Subject: Supplemental Response to Questions
Concerning Slenderness Ratio and Lateral
Unbraced Length of Certain Support
Steel Members -- Byron Unit 1, NRC
Docket No. 50-454

The purpose of this letter is to supplement the information provided in Reference (a) concerning the results of our evaluation of the slenderness ratio and lateral unbraced length limitations applied to certain component support steel members on Byron Unit 1. This evaluation is intended to resolve the questions raised in Section C.7.d and D.2 contained in Reference (b).

Subject: Byron Generating Station Units 1 and 2
Braidwood Generating Station Units 1 and 2
Design Concerns
NRC Docket Nos. 50-454/455 and 50-456/457

Hanger No.: H056
Drawing No: 6/20-E-1-3052
Building: Auxiliary

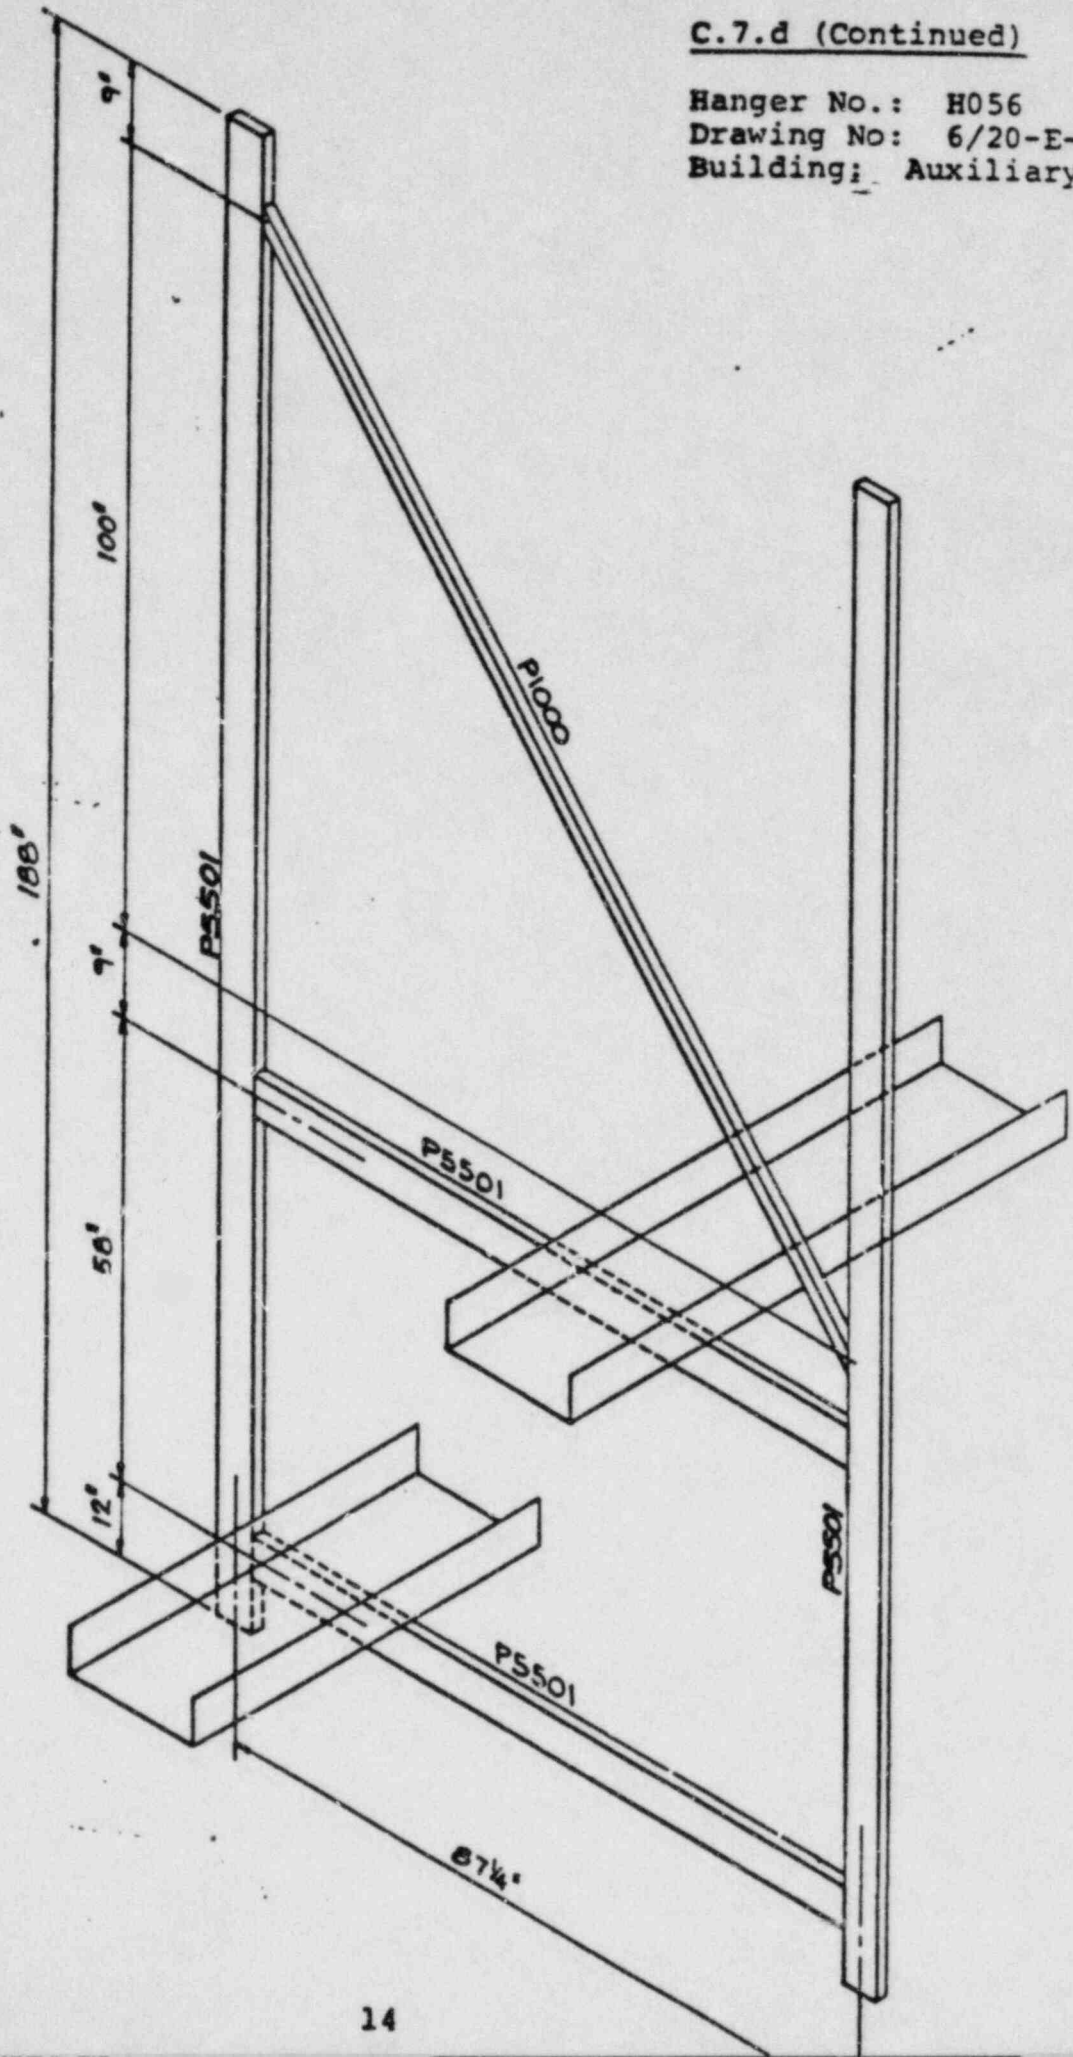
Review of Category I conduit supports typical support types and load tables Dwg. 6E-0-3393B - Support type CF and MCF (Floor to Ceiling) and type CC and CP maximum load tables. It appears that the KL/r for many of those shown exceeds 200 (Reference Calc. Book 19.1.3).

merely afford a degree of stiffness such that undesirable lateral movement ('slapping' or vibration) will be avoided. These limitations are not mandatory." The attached sketch shows hanger H056 on drawing 6/20-E-3052 which is the cable tray hanger that was alleged to have a KL/r ratio exceeding allowable limits. The vertical member has a calculated KL/r value of 192. The internal diagonal has a calculated KL/r value of 208.

C.7.d (Continued)
Hanger No.: H056
Drawing No.: 6/20-E-1-3052
Building: Auxiliary

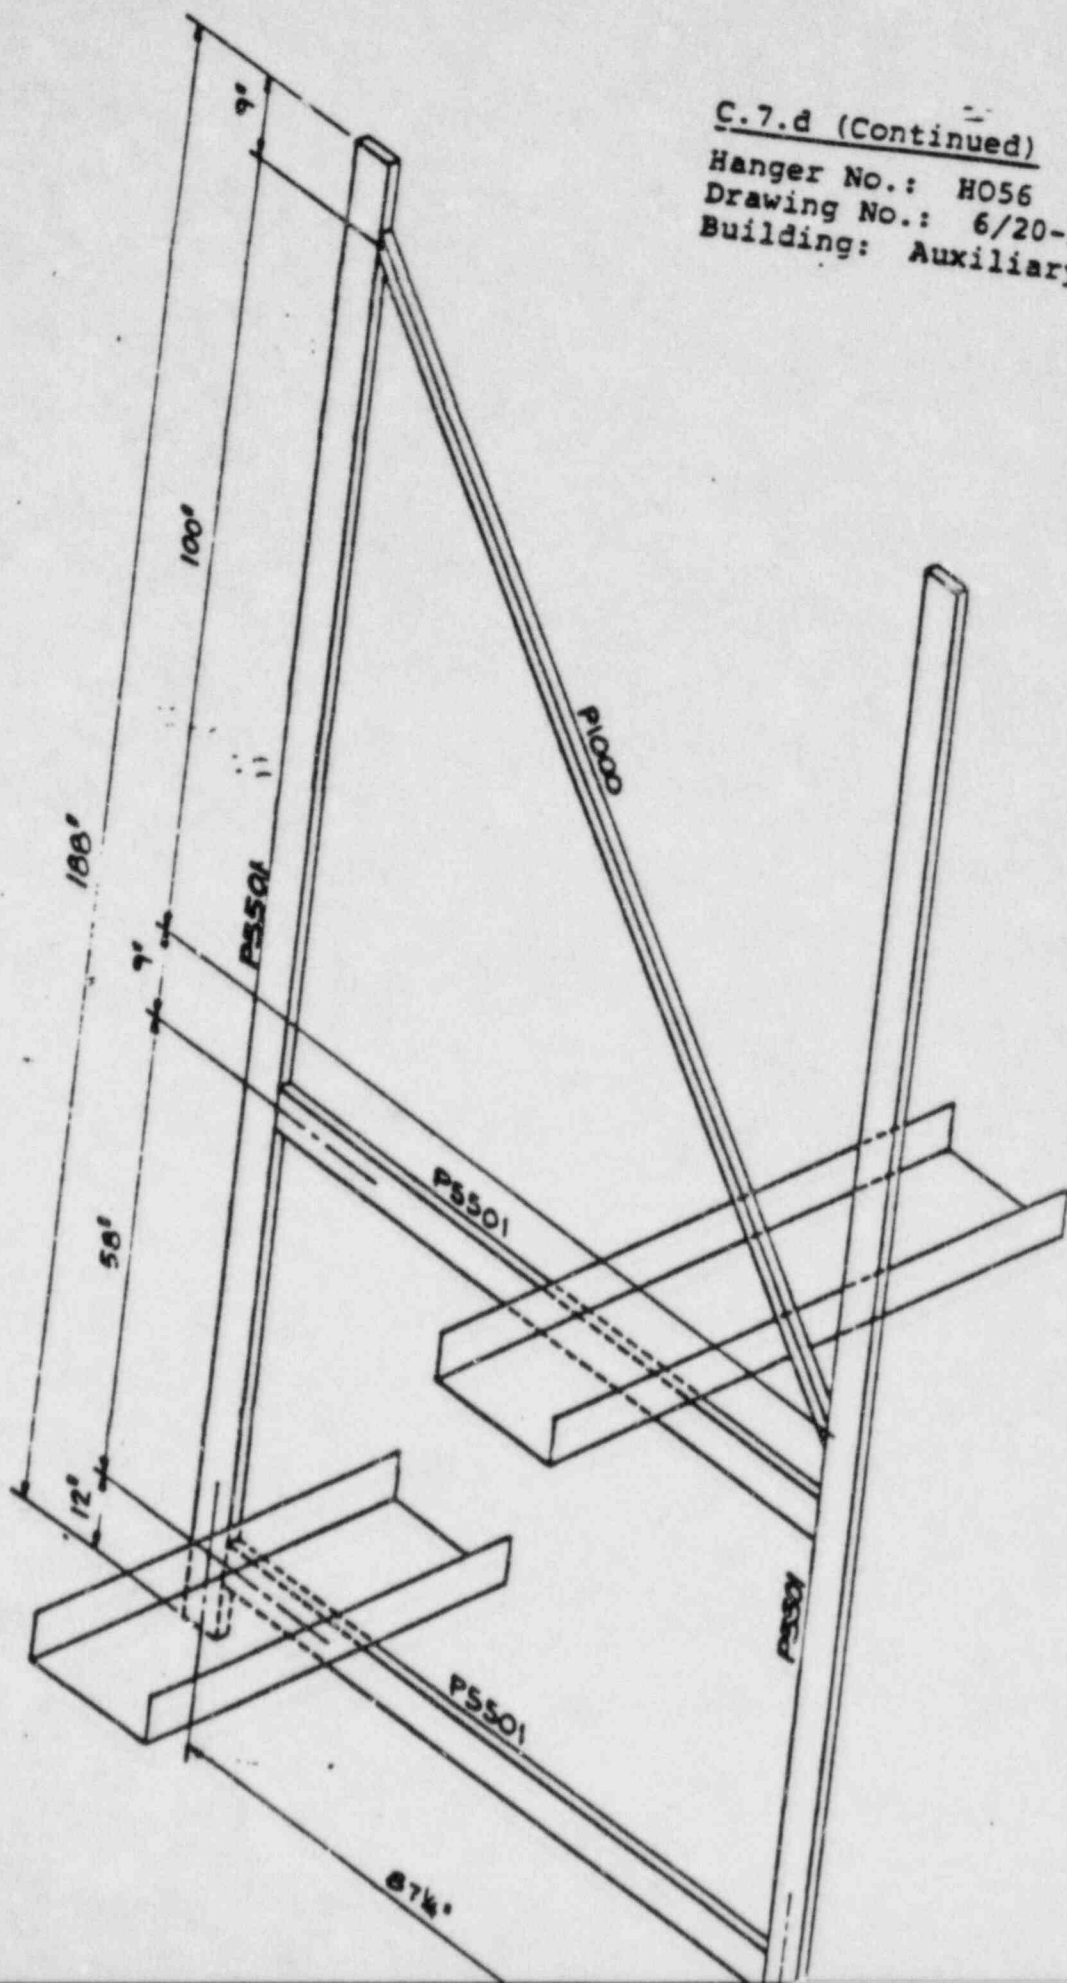
Review of Category I conduit supports typical supports types and load tables Dwg. 6E-0-3393B - Support type CF and MCF (Floor to Ceiling) and type CC and CP maximum load tables. It appears that the KL/r for many of those shown exceeds 200. (Reference Calc. Book 19.1.3)

The attached sketch shows hanger E056 on drawing 6/20-E-1-3052 which is the cable tray hanger that was alleged to have a KL/r ratio exceeding allowable limits.

The vertical member has a calculated KL/r value of 192. The internal diagonal has a calculated KL/r value of 208.

Although the internal diagonal has a KL/r value slightly higher than 200, it is a secondary member in the sense that it does not carry gravity loads (i.e., cable or tray weight) and is not required for stability of the hanger. This diagonal only resists lateral loads due to a seismic event. The loads are of short duration and are reversible. Therefore, the local buckling due to this short term transient will not effect the overall behavior or structural integrity of the support.

In addition, this hanger is top supported and is a tension type system. Therefore, this hanger will not locally buckle. However, if local buckling should occur in this type of system, the diagonal would be restored to its original configuration due to the vertical gravity load and the reversible longitudinal loads.
